ADDENDUM #09

INVITATION TO BID #01

RENOVATION TO THE BRANFORD POLICE HEADQUARTERS 33 LAUREL STREET BRANFORD, CT 06096

November 5th, 2024

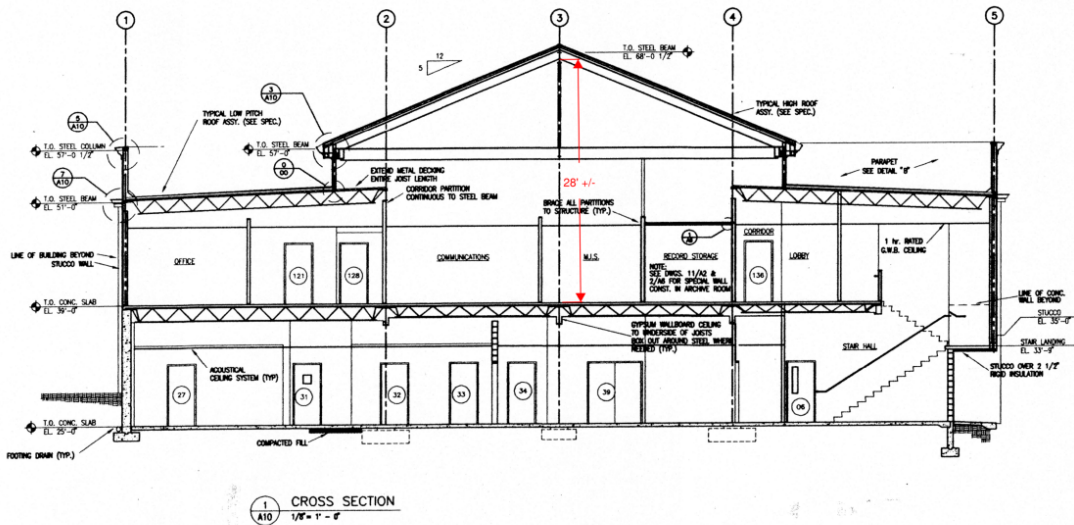
8. **ALL Bidders** should be aware of the existing conditions required to support your systems as shown on A1.2 revised with Supplement #6 dated 10.15.24. See screenshot below. Approximate height to peak is approximately 28' +/- AFF. The W12x19 beams previously thought to exist between the W14x22's and W16x26's do not exist throughout as shown in the existing conditions drawings provided via Supplement #2 dated 10.09.24.
